MEMORANDUM

From: Colby Anderson, VLMK Project: Sherwood C.C.

Subject: Land Use Modification Clarification Project Number: 20210190

SHERWOOD COMMERCE CENTER LAND USE MODIFICATION EXHIBIT

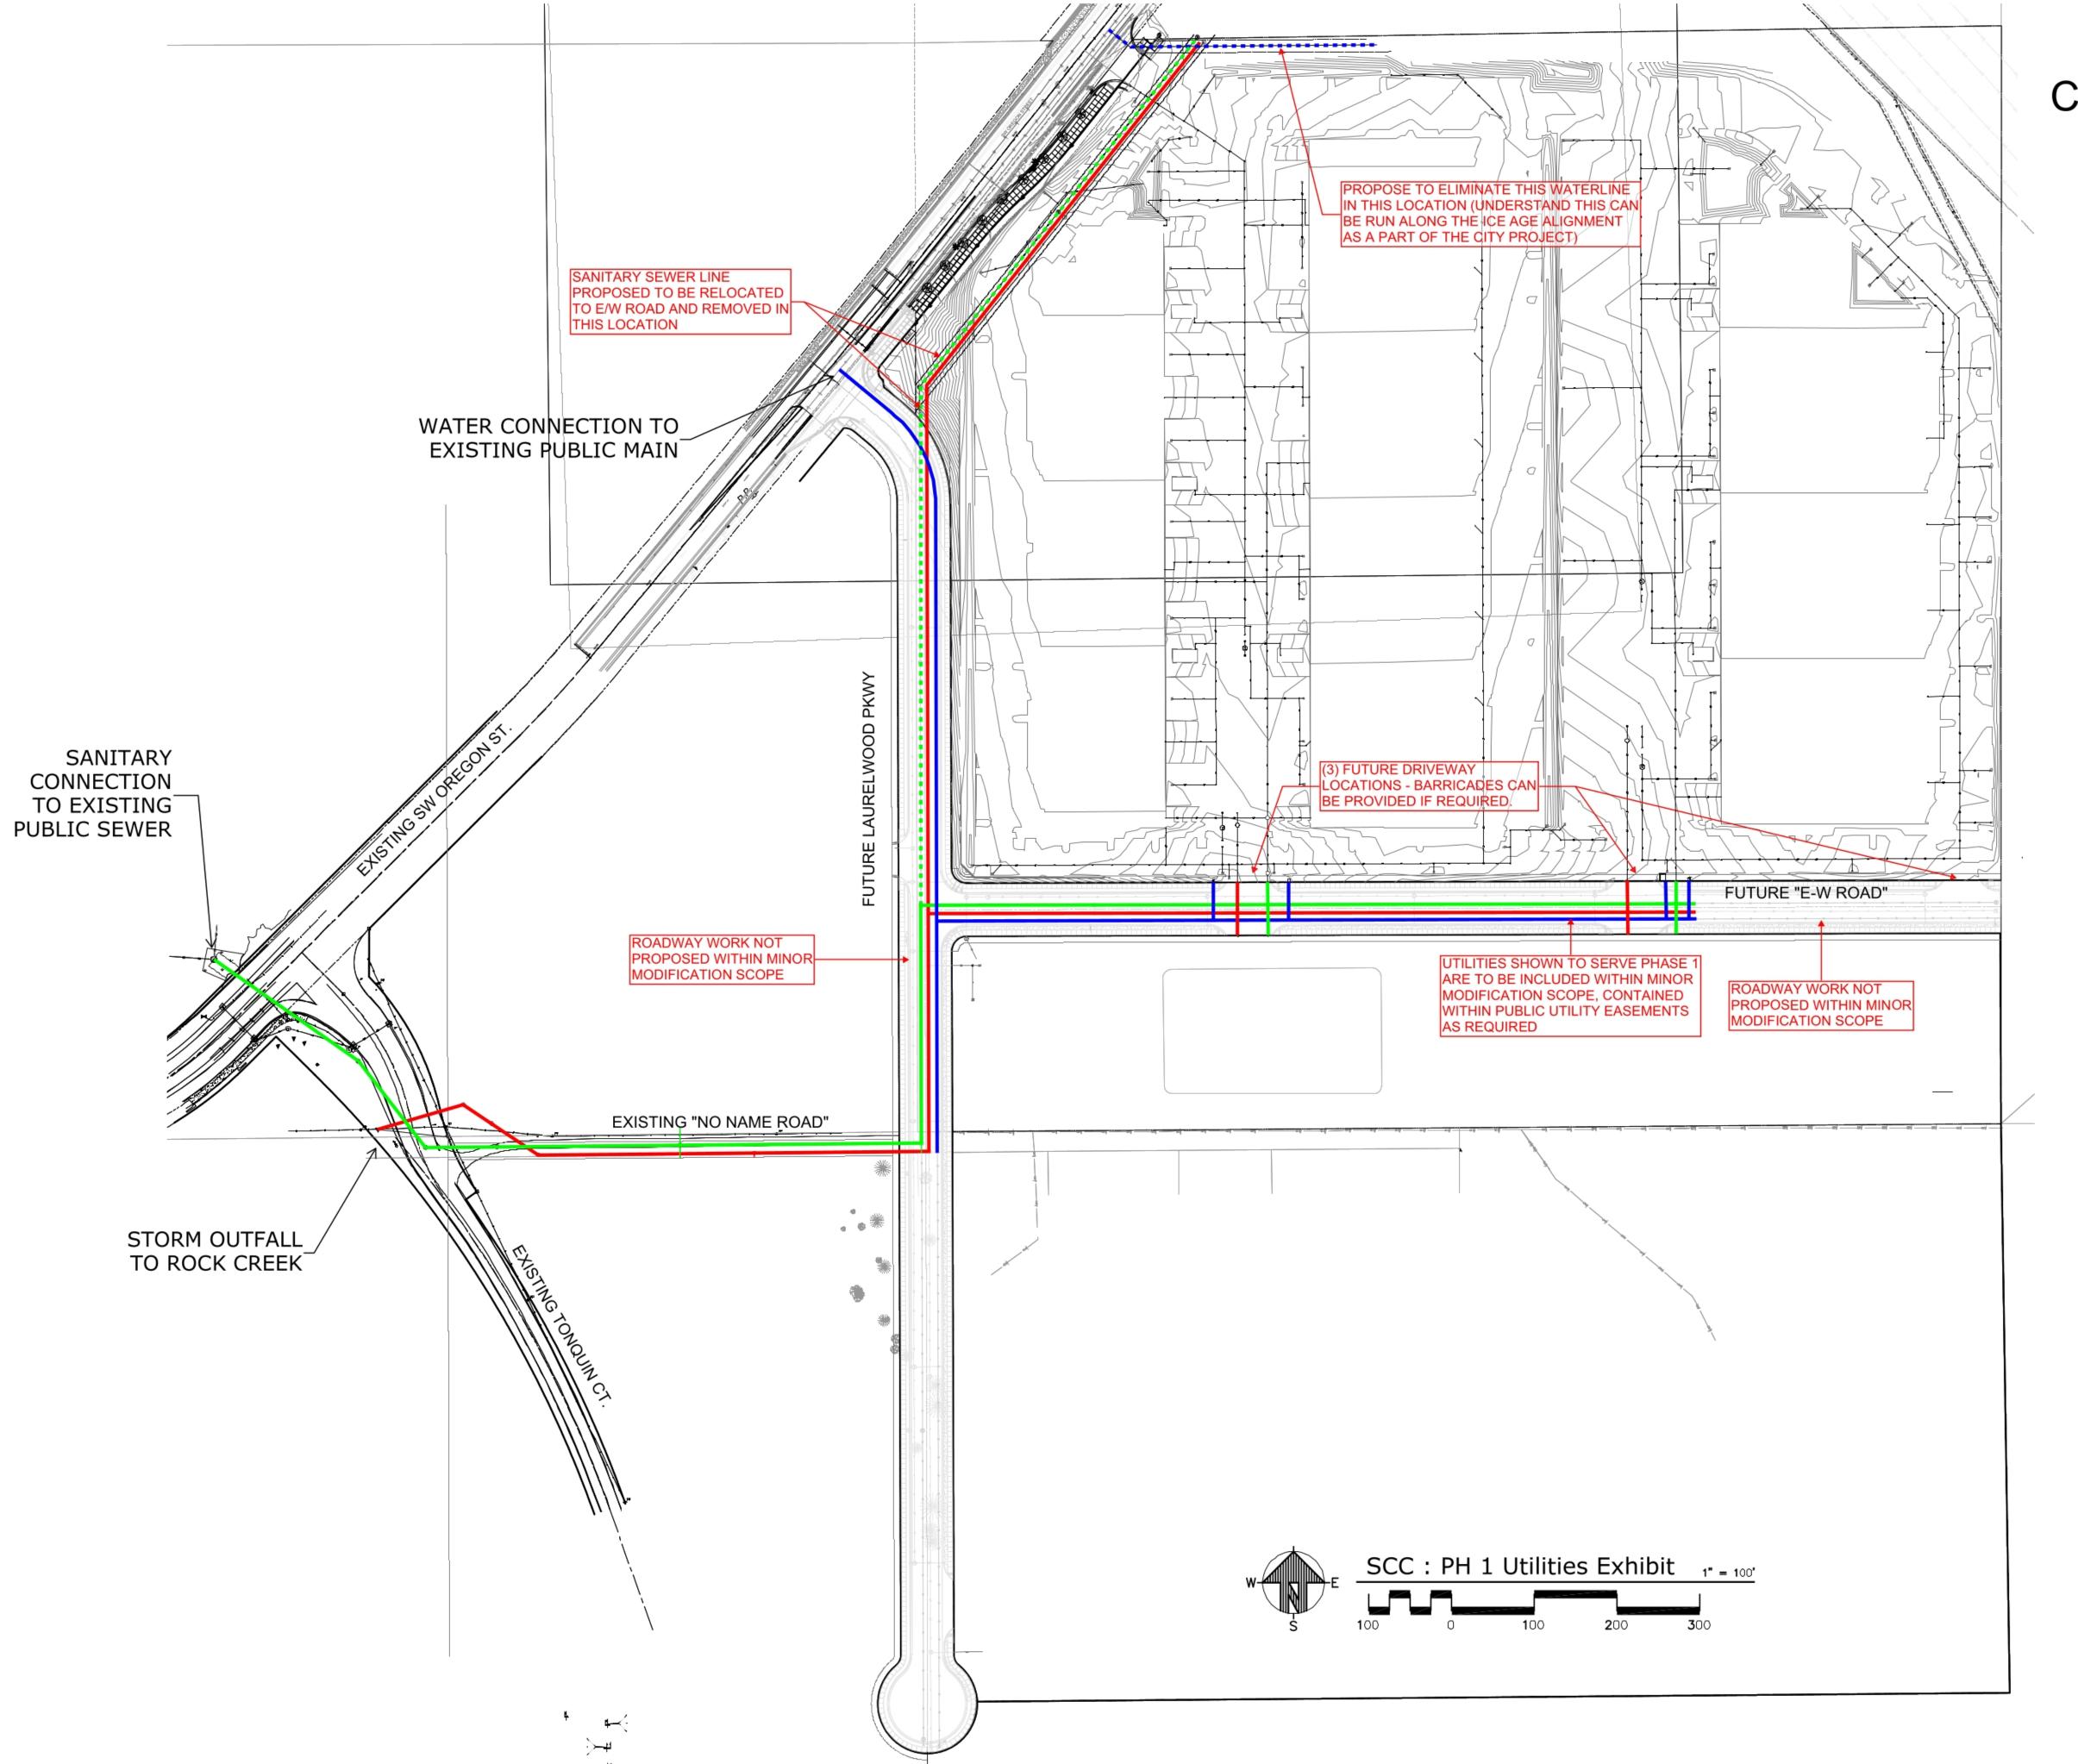
- 2. The applicant and city have coordinated the Sanitary Sewer and Water lines and are proposing to make the following changes:
 - a. Remove the sanitary line previously conditioned to run up the West side of the property (North of East/West Road) and crossing along the Oregon St. frontage to serve properties to the North and East. This will be replaced with a public line along the Southern border of our property (under future East/West Road), which will provide service to the other surrounding properties. See attached exhibit for additional clarity on this item.

- b. Additionally, the waterline previously conditioned along the Northern boundary of the property is proposed to be removed from our site and relocated to be within the City project for Ice Age Drive. Our understanding is that this would be a favorable change for the City as well as the applicant. See attached exhibit for additional clarity on this item.
